October 18, 2016

**Subject: Sweetwater Uranium Project – Docket Number: 40-8584
Source Material License SUA-1350 - Sweetwater County, Wyoming – Completion of
the Response to the August 25, 2016 Letter - Attachment 2 - Groundwater
Monitoring Plan and Attachment 3 - Air Effluent Monitoring Program**

**Responses to NRC Letter Dated August 25, 2016
Sweetwater Uranium Facility, Docket Number: 40-8584
Source Material License SUA-1350
License Condition 11.4, Groundwater Monitoring**

FIGURE 5-7
PROPOSED MONITORING WELLS FOR THE FIRST NEW TAILINGS
IMPOUNDMENT AND EVAPORATION PONDS

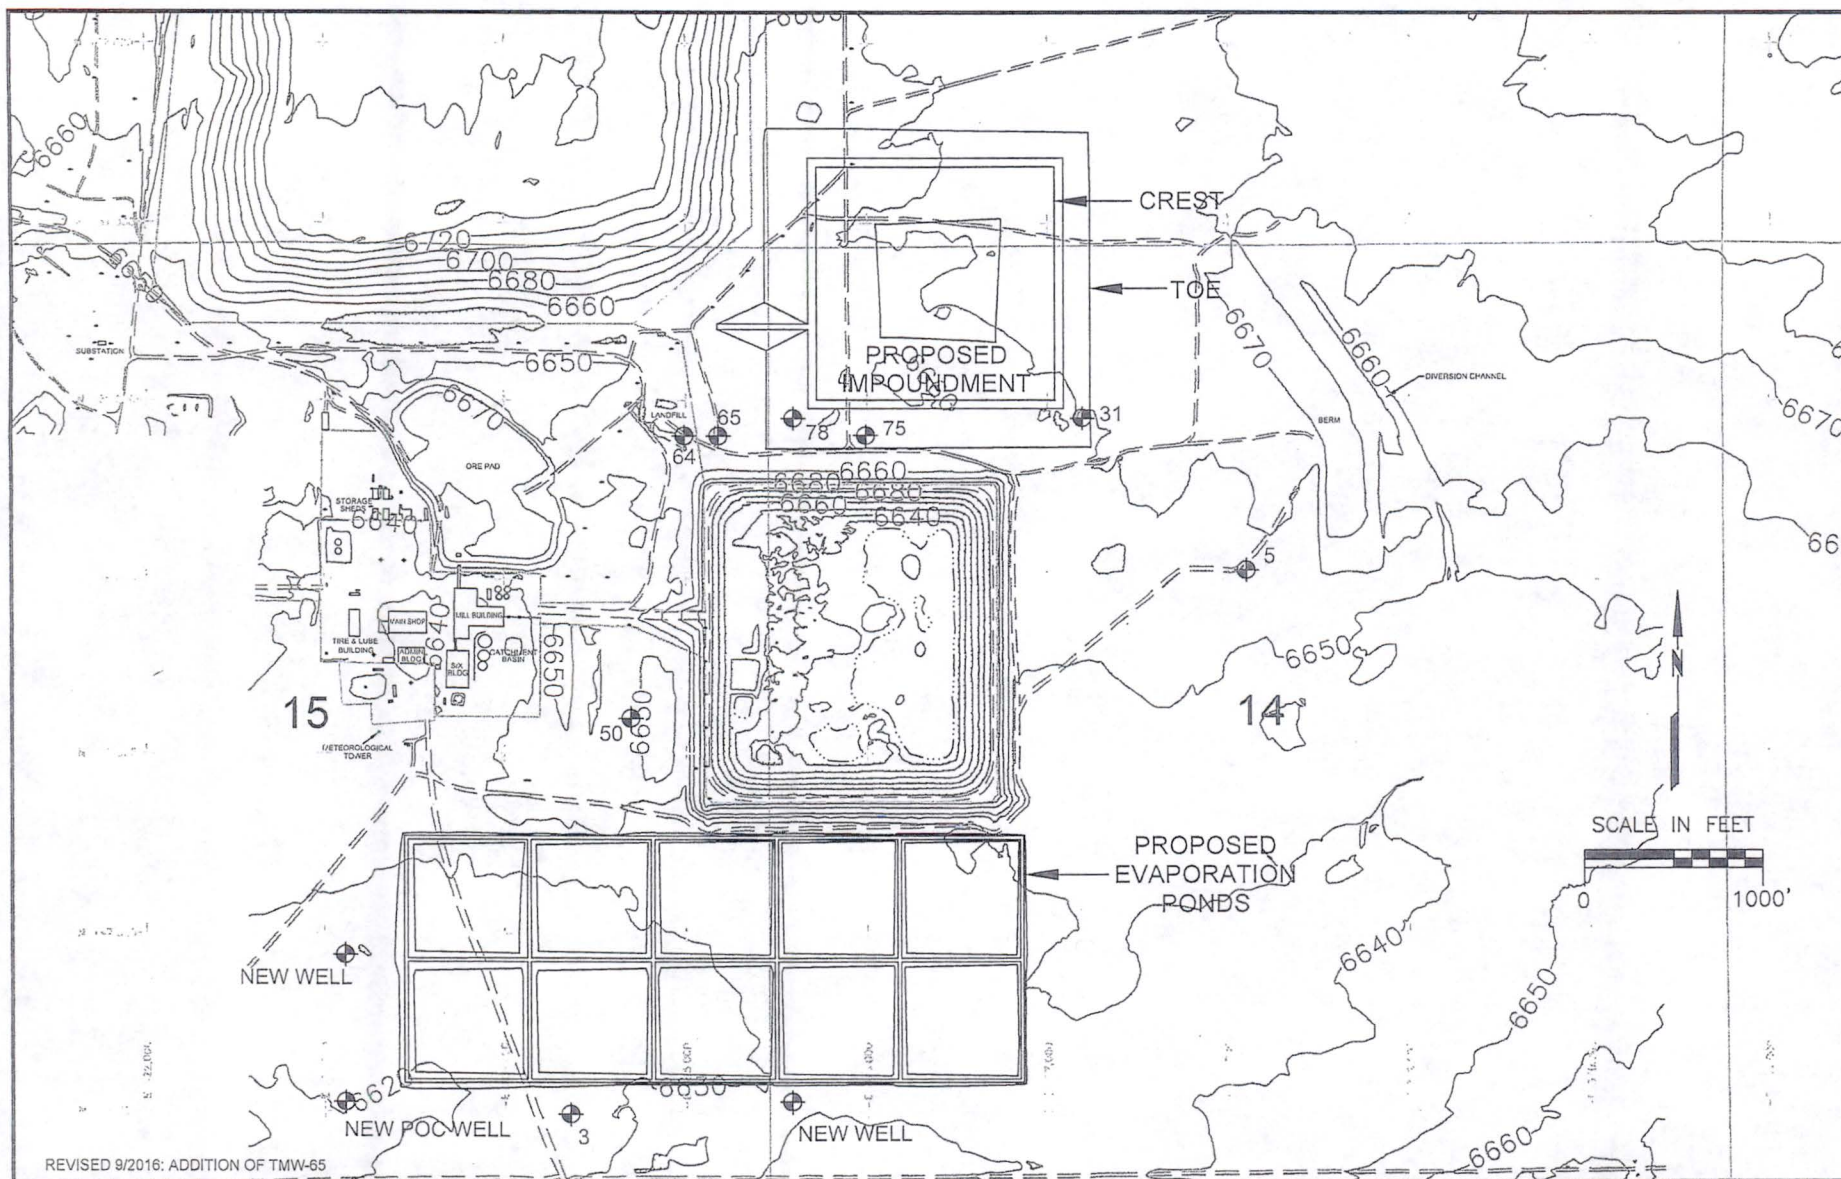
Water quality monitoring within the Battle Spring Aquifer in the vicinity of the proposed evaporation ponds was proposed by Kennecott and accepted by NRC in TMWs 3 and 50, as well as three new wells. These wells are also shown on Figure 5-7, Proposed Monitoring Wells for the First New Tailings Impoundment and Evaporation Ponds, modified by Telesto from Shepherd Miller (1997b).

Proposed tailings impoundment monitoring wells TMWs 31, 64, 65, 75 and 78 (Figure 5-7) are all located either south or southwest of the first new tailings impoundment. In the unlikely event of an impoundment leak through all three liner layers, impacted groundwater would follow flow paths either in the long-term regional southwest groundwater flow direction or toward short-term localized pumping zones, also located south or southwest of the impoundment. By either flow path, each of these five wells will be located in the downgradient flow direction from the new tailings impoundment (Figure 2).

Proposed evaporation pond monitoring well TMW 3, and the three new monitoring wells will be located either south or west of the ponds. Groundwater impacted by the unlikely event of an impoundment leak through all three liner layers flowing along the regional groundwater flow path would encounter these wells (Figure 2 and modified Figure 5-7). In addition, TMW-50, north of the evaporation ponds, is proposed to be a monitoring well. This well is located between the proposed pond site and localized pumping associated with pumpback wells. In the event of an unlikely impoundment leak through all three liner layers, and if the impacted groundwater would follow a flow path toward pumping wells, TMW-50 would be downgradient of the ponds (Figure 2). Whether groundwater flow would be directed toward pumpback wells and TMW-50, or toward the southwest with the regional gradient, will depend on the magnitude of pumping.

FIGURE 5-3
NRC MILL AREA MONITORING LOCATIONS, RESUMED OPERATIONS,
FIRST NEW TAILINGS IMPOUNDMENT AND EVAPORATION PONDS

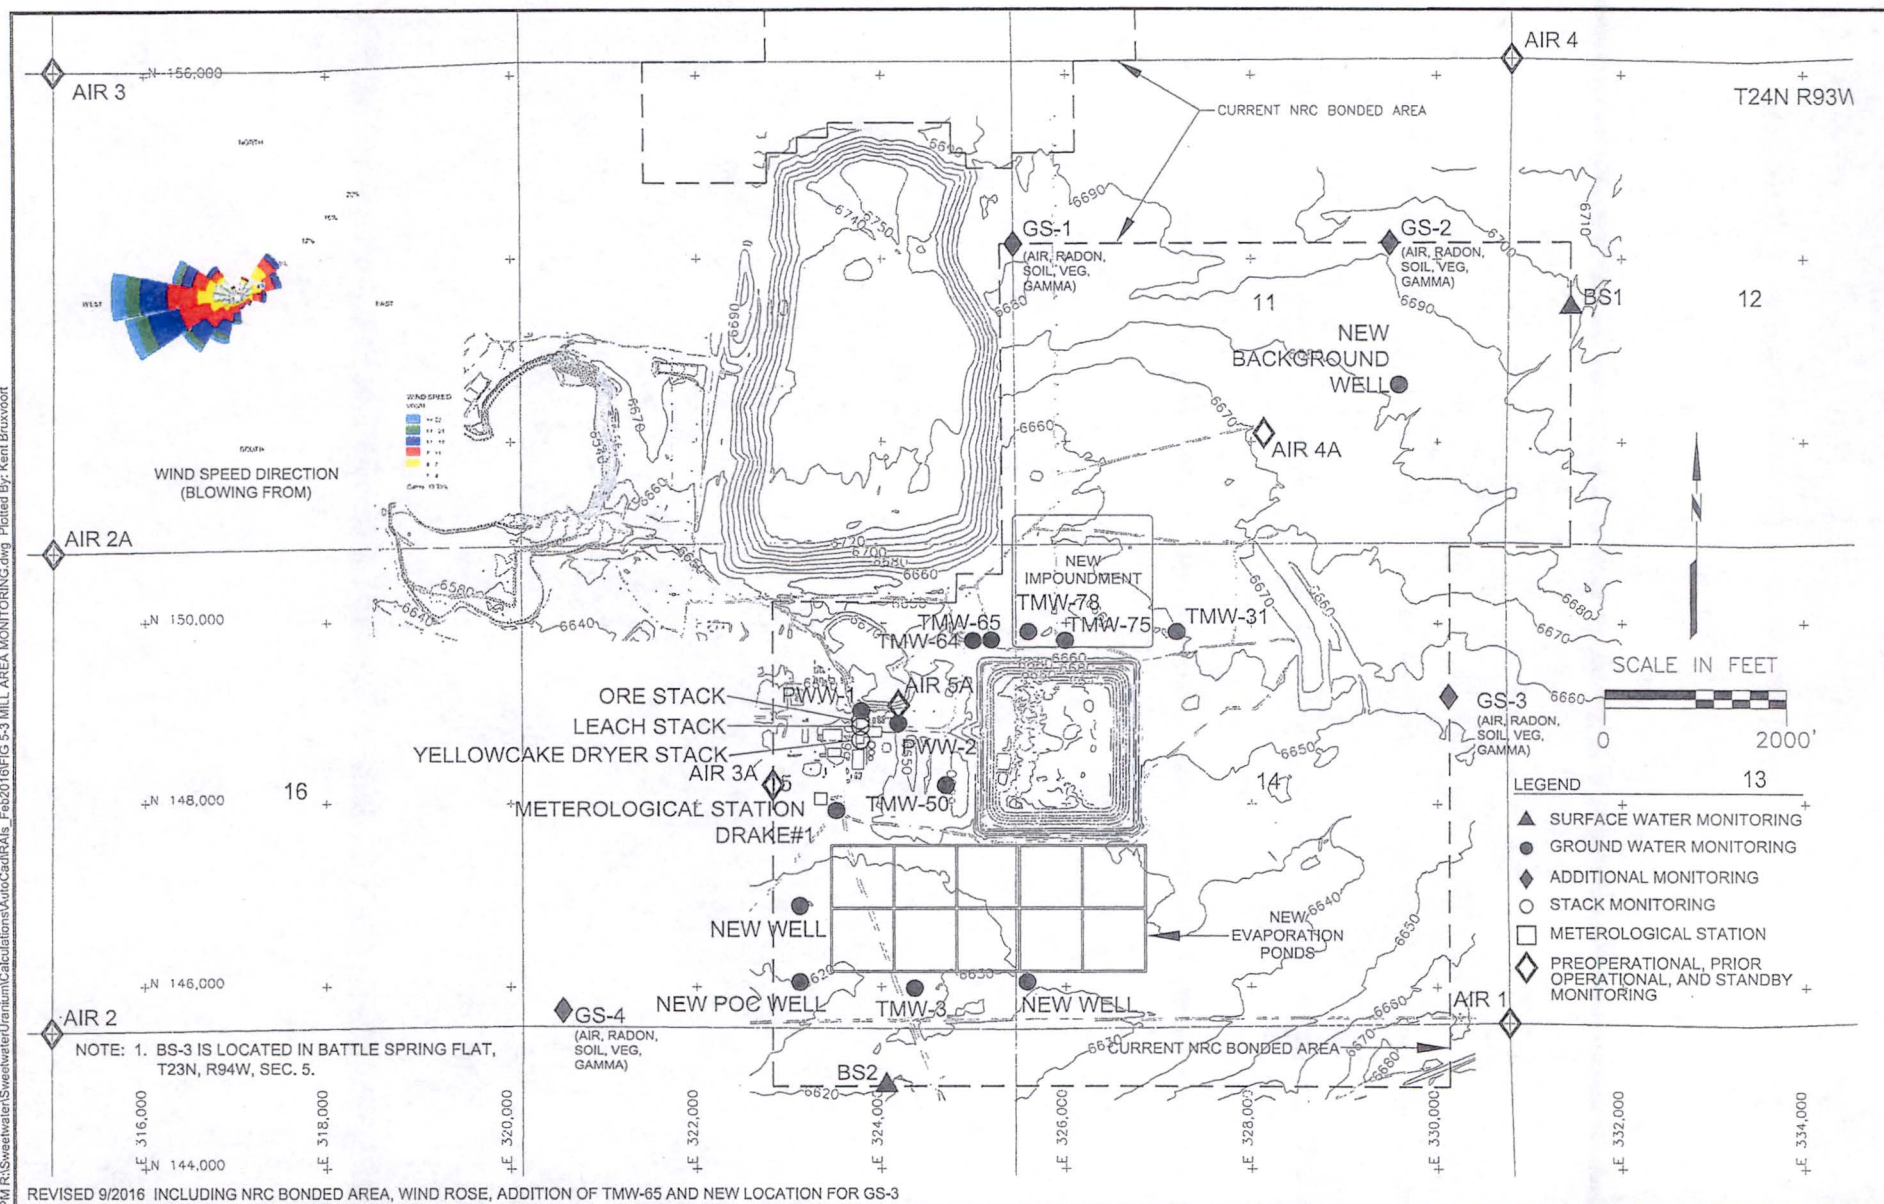
The location of the air sampling stations for resumed operations was depicted in Figure 5-3: "Nuclear Regulatory Commission Mill Area Monitoring Locations" of *Final Design – Volume VII – Operations Plan* (Shepherd Miller, Inc., 1997. Attached please find a revised Figure 5-3 showing

A wind rose for the facility based on 2004 through 2014 data has been placed for reference on the revised Figure 5-3. The wind rose was included as Figure 9: "Sweetwater Wind Rose, Onsite Data, 2004 through 2014" from the *Supplement to Licensee's Environmental Report – Sweetwater Uranium Project Docket Number: 40-8584 - Source Material License: SUA-1350*, submitted to the NRC on June 3, 2016 and currently in review. The wind rose indicates a predominant wind direction at the facility toward the east and has been placed on the revised Figure 5-3 to confirm the proper placement of monitoring station GS-3 as depicted thereon. This location places the GS-3 monitoring station at the eastern edge of the Nuclear Regulatory Commission (NRC) bonded area and on the eastern edge of lands held by Kennecott Uranium Company via unpatented mill sites.
